Architectural Review Board

Staff Report (ID # 11181)

Report Type:	Action Items	Meeting Date: 11/5/2020
Summary Title:	3rd ARB meeting Castilleja School Project	
Title:	<p>PUBLIC HEARING/QUASI-JUDICIAL: 1310 Bryant Street Castilleja School Project Third ARB Hearing [19PLN-00116]: Recommendation to the City Council Regarding Architectural Review of Castilleja School's Phased Campus Redevelopment Proposal. Zone District: R-1(10,000). Environmental Review: A Final Environmental Impact Report (EIR) was Published July 29 and 30, 2020. For More Information Contact Amy French, Chief Planning Official, at amy.french@cityofpaloalto.org</p>	
From:	Jonathan Lait

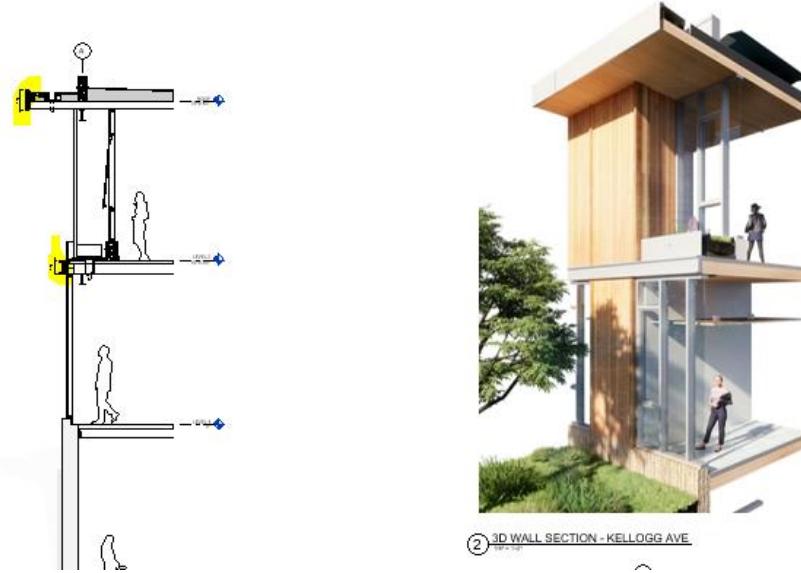
<p>6. Emerson Side of Campus – sound wall - Sound wall function/look</p>	<p>The fence has vertical articulation with vertical wood boards and battens that relate to the patterning on the new building. The design of the sound wall was based on the direction of the acoustician. Per Salter's March 18, 2018 report on the master plan:</p> <ul style="list-style-type: none"> ○ The new pool will be recessed approximately 15' below grade and include a solid barrier that extends upward approximately 6' above grade and will include an angled element on top facing in towards the pool

<p>The acoustic wall is a solid wood 6'-0" fence with angled top.</p> 
<p>7. Photovoltaic Screening – show how it will look</p>	<p>The revision intent to improve elevations was to be less impactful, with consideration as to how the roof edge meets the sky by reducing vertical elements, and consideration of the efficiency of the PVs. Two strategies have worked well in past projects.</p> <ol style="list-style-type: none"> 1) One option is to keep the PVs flat so that they sit lighting above the roof and their thin edges blend into the skyline read.   <ol style="list-style-type: none"> 2) A second option, which helps with efficiency, is to slightly cant them.
